January 11, 2022
7:00 PM
Planning Board Agenda

Public hearing on applications for Subdivision Approval (lot merger) and Site Plan Approval, three-story mixed-use residential and commercial development, 364 Main Street, submitted by O'Donnell Construction Corp.

Re: 364 Main Street, Beacon, New York
Site Plan Application – Responses to Comments

Scale: $\frac{1}{8}$ " = 1'-0"

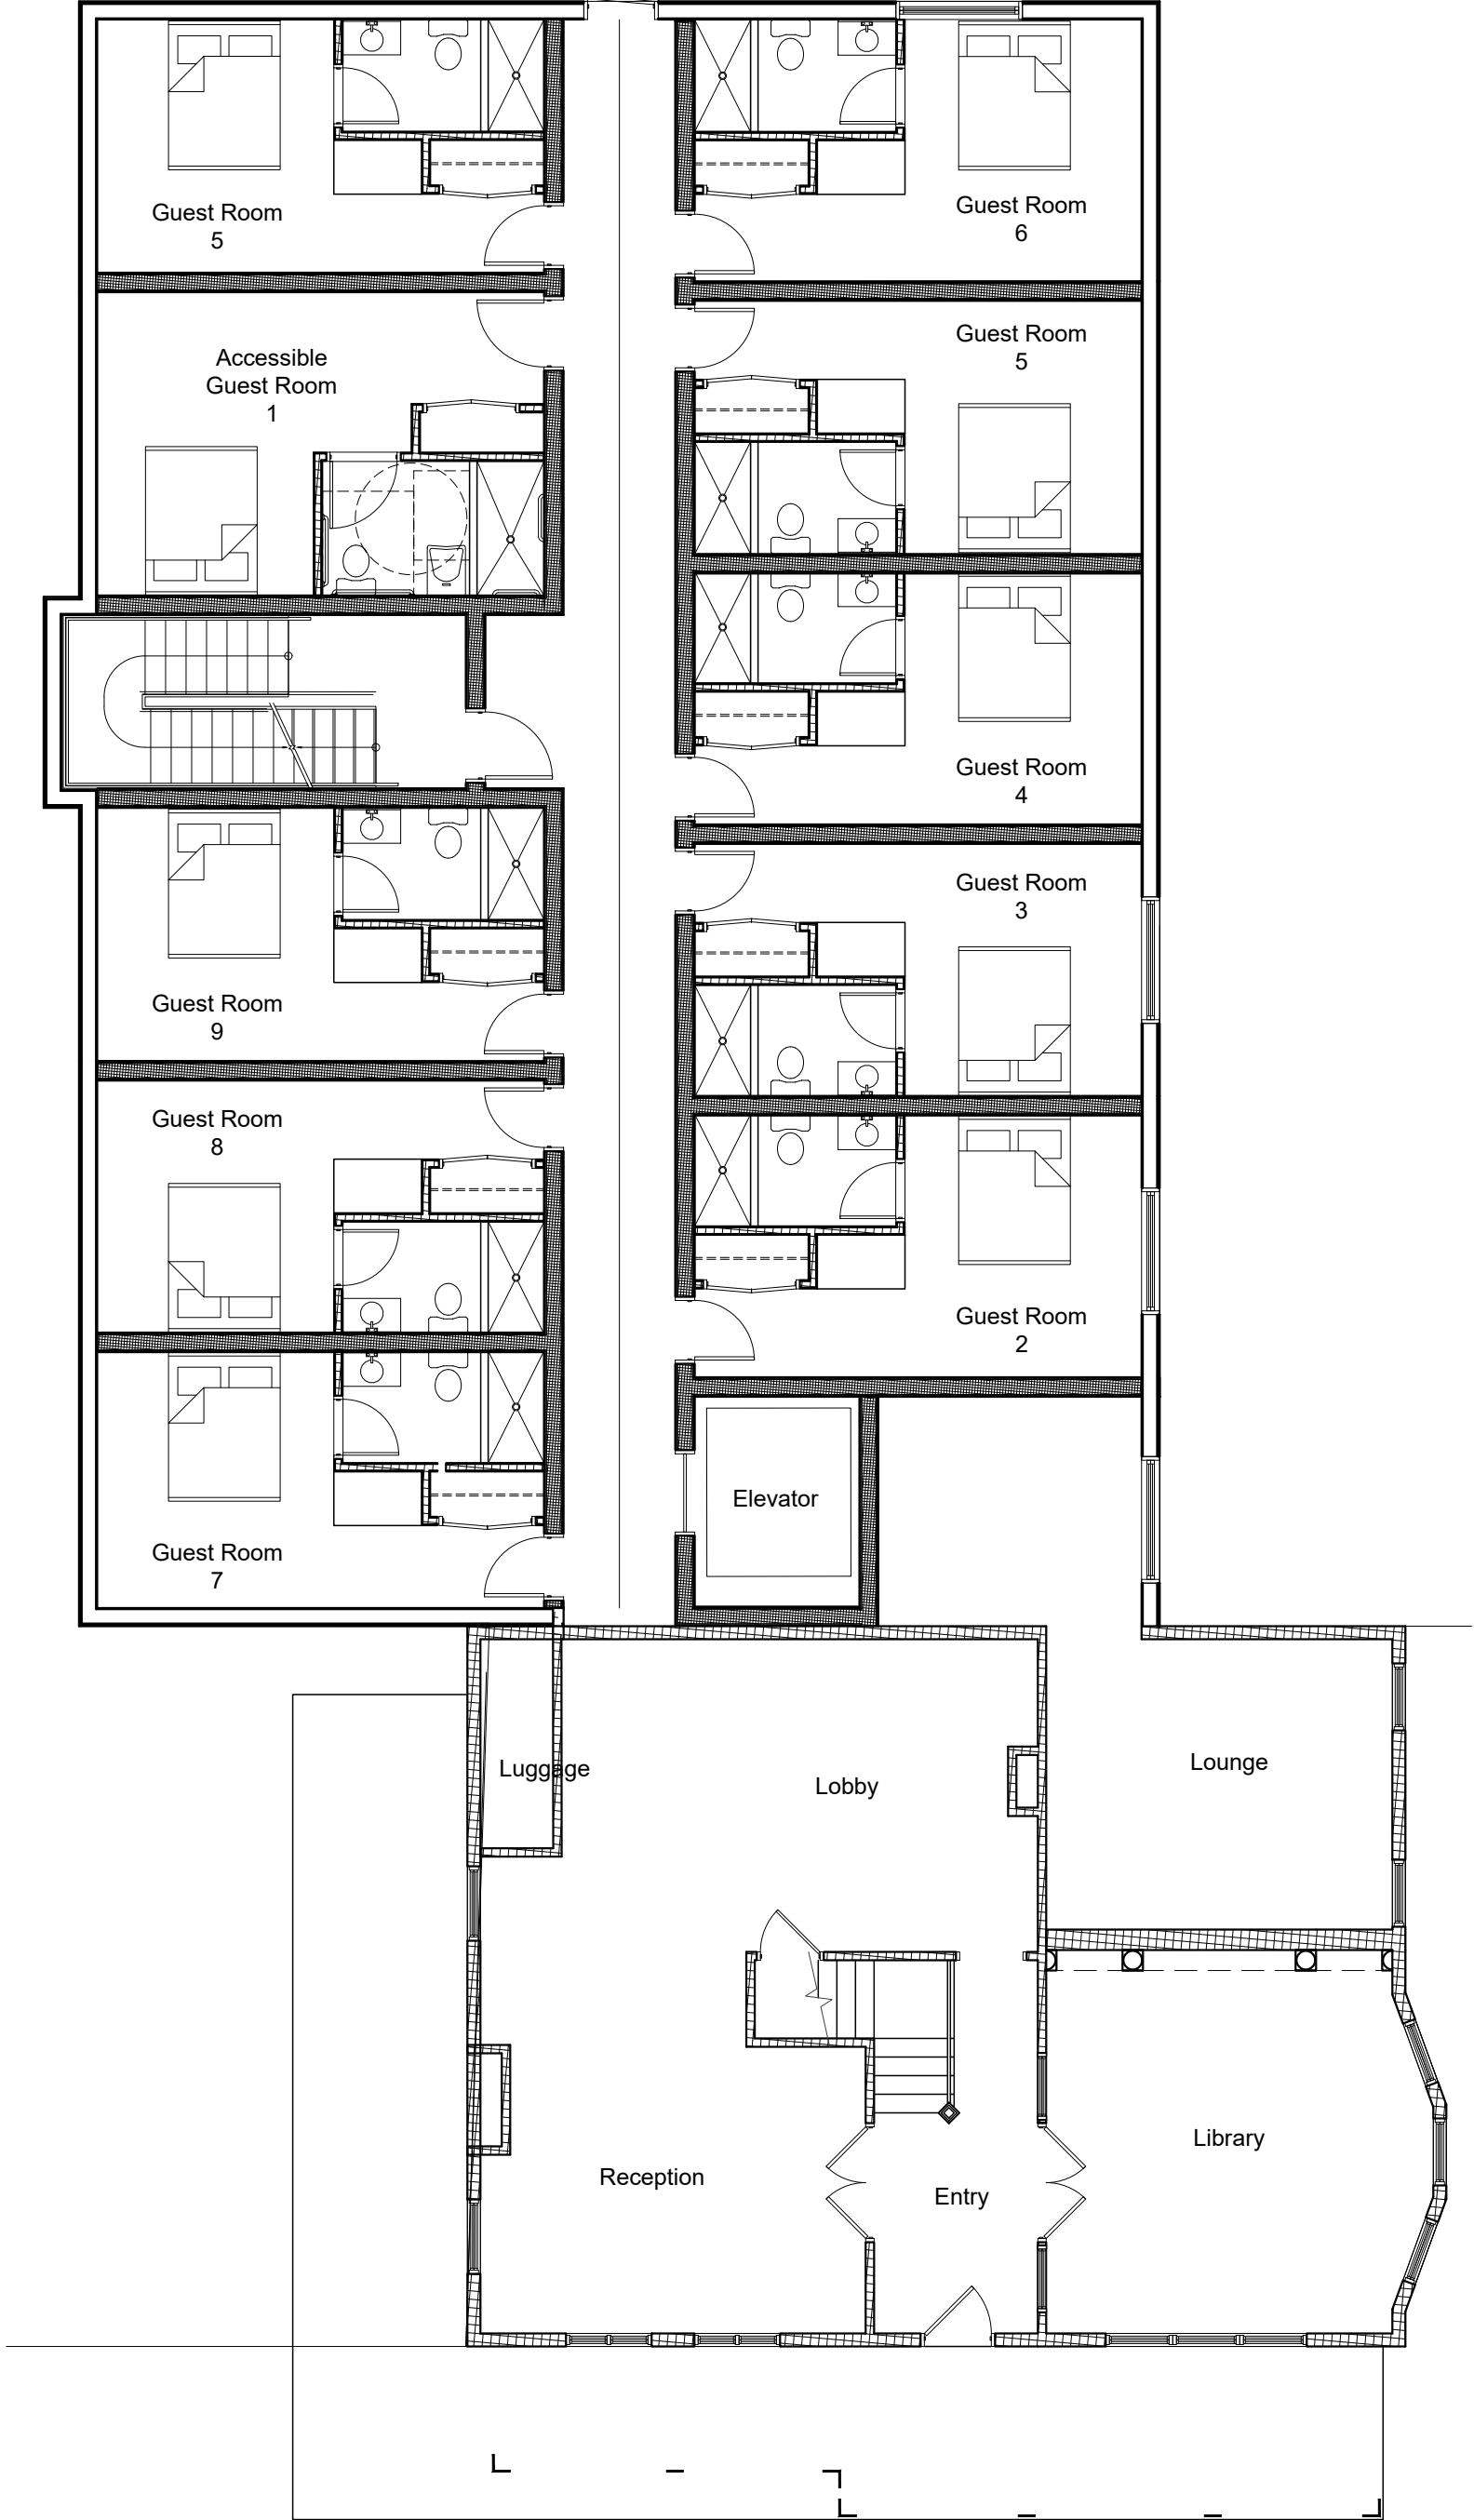
4. On the Sheet 5 Floor Plans, 31 guest rooms are still shown. The hotel elevations will need materials and colors identified.
5. All exterior construction must meet the standards in Chapter 134, Historic Preservation, and will require a Certificate of Appropriateness.

SHEET: 8 OF 13

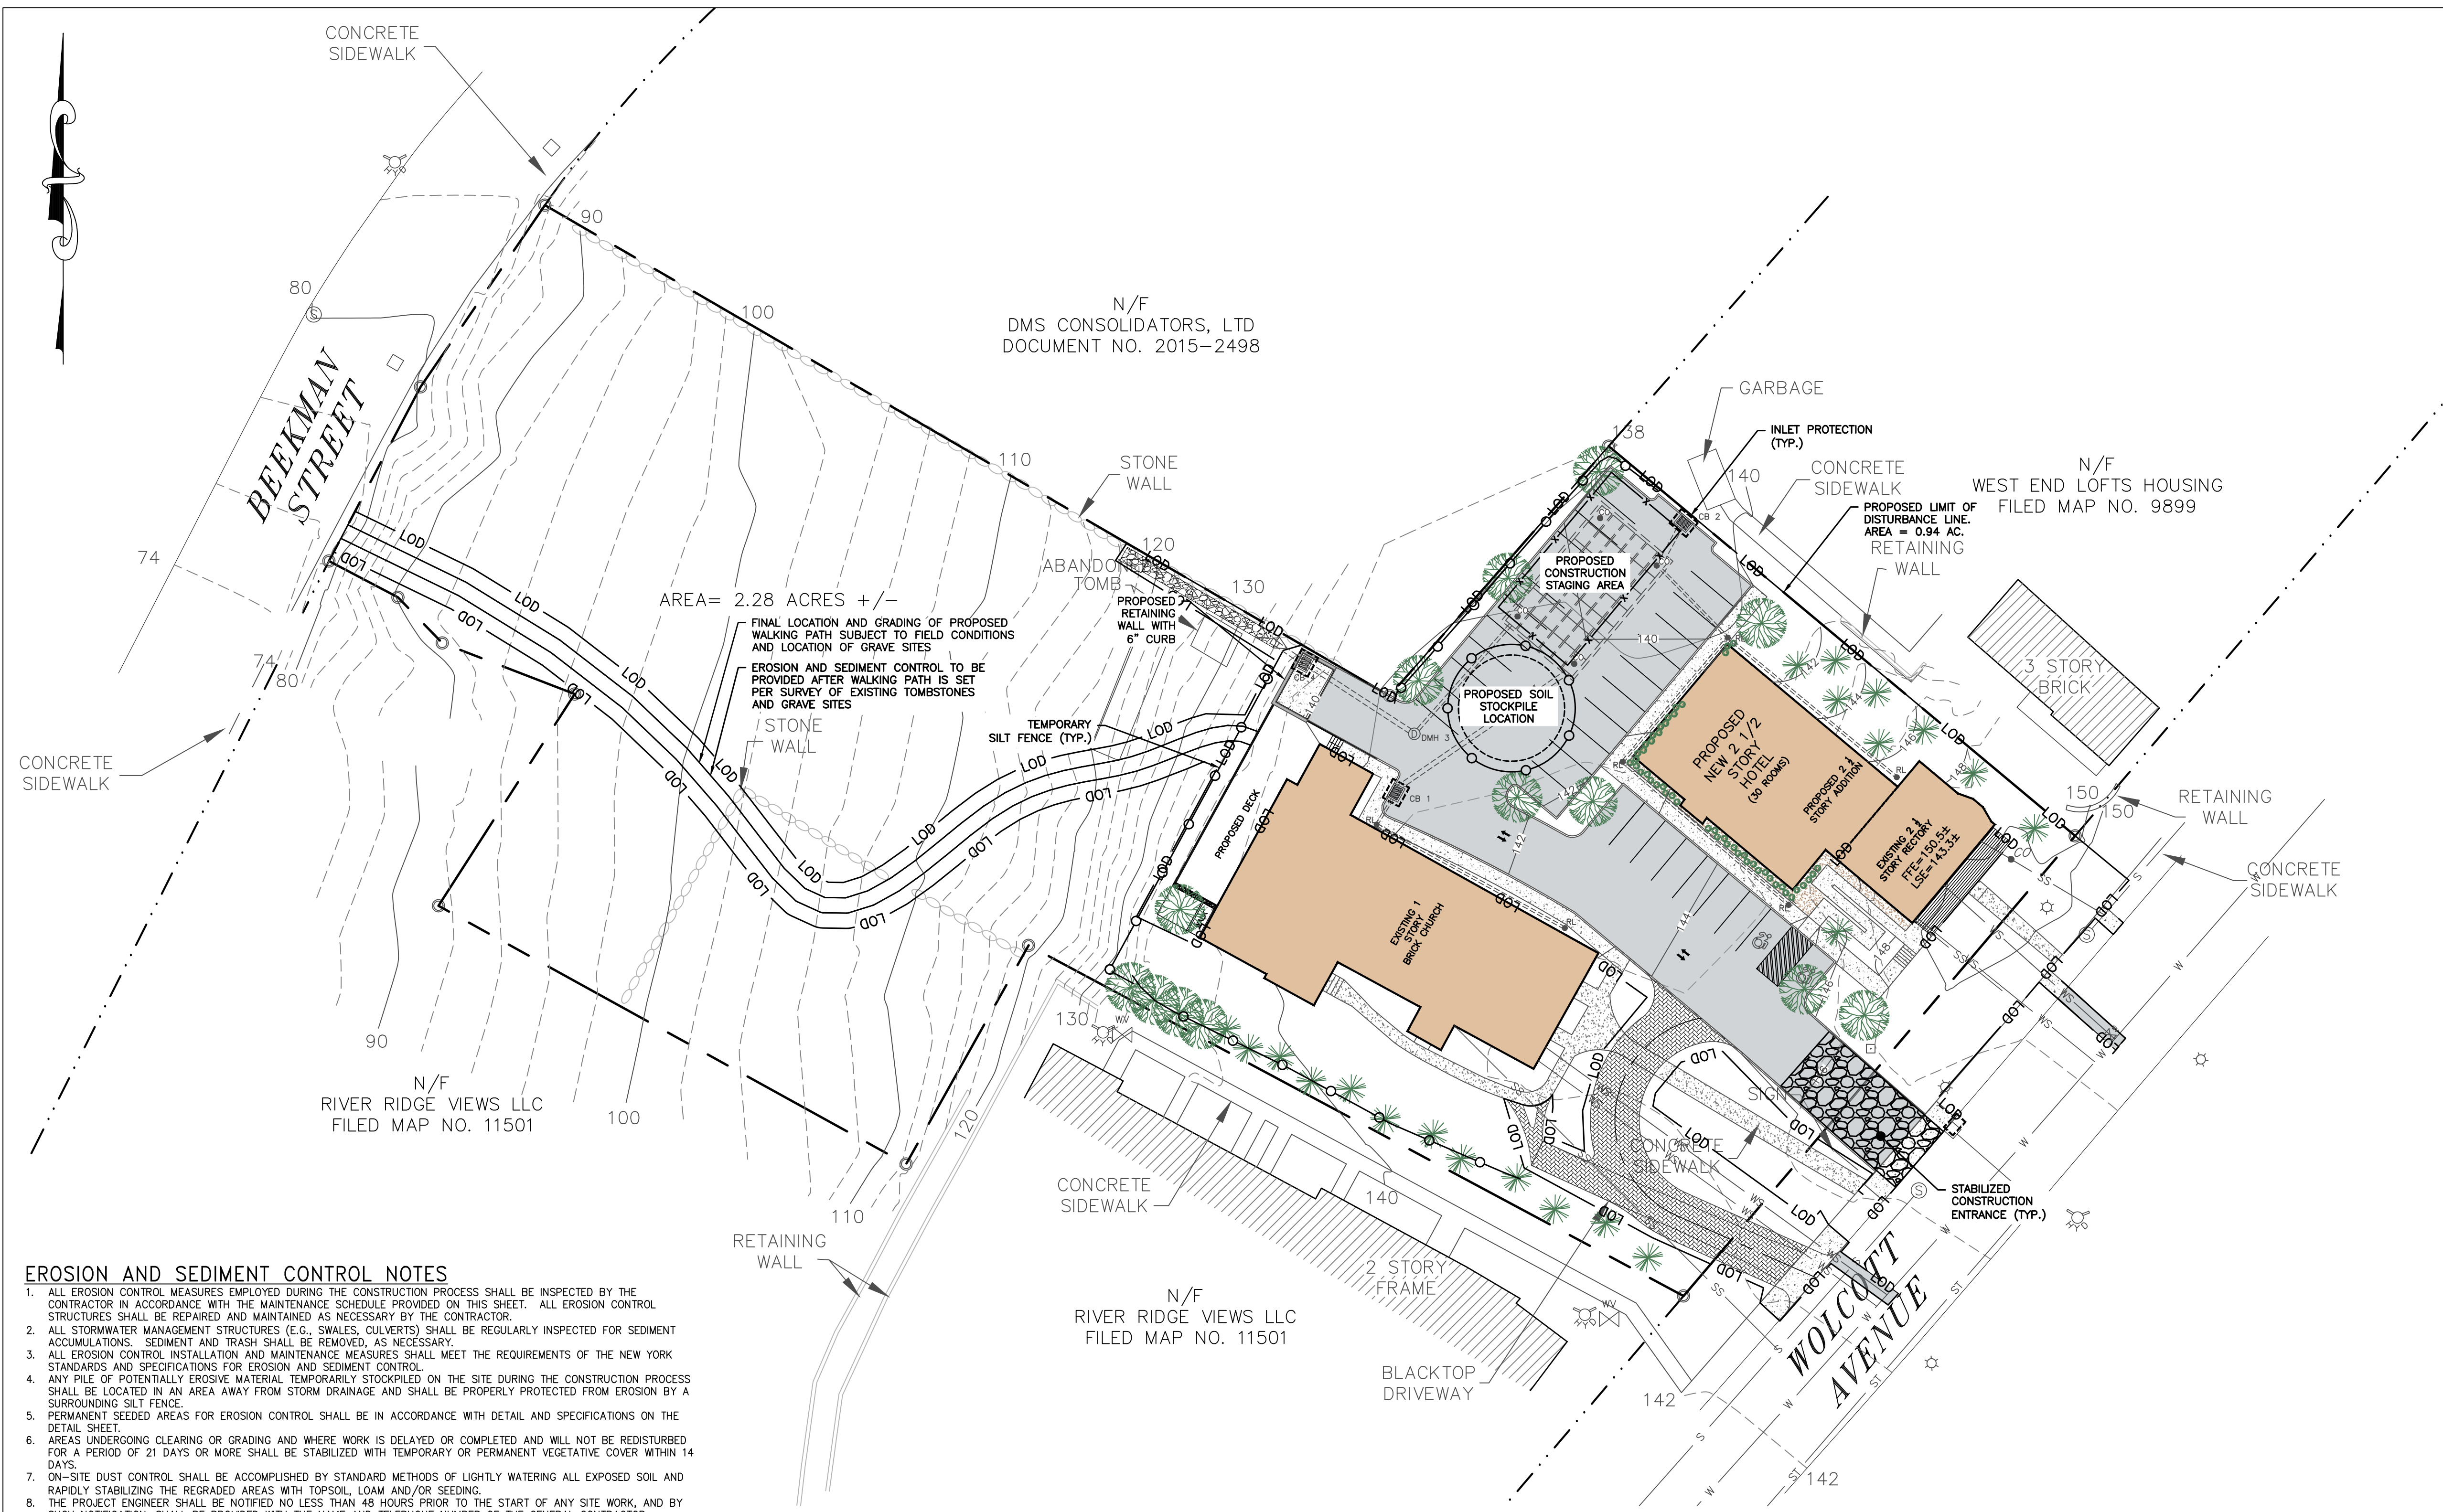
2. Plan shows an underground stormwater management structure to be constructed in the parking lot located to the east of the hotel. Based upon the construction details provided on Sheet 9, it appears that the proposed system will be an infiltration system. Soil testing will need to be conducted as part of the design of this system and the testing shall require witnessing by the City Engineer's office. The applicant's consultant shall contact the City Engineer's office to schedule the soil testing to allow for the witnessing of the required soil testing. ***Applicant's engineer notes that the soil testing will be coordinated with the City Engineer's office, weather permitting.***
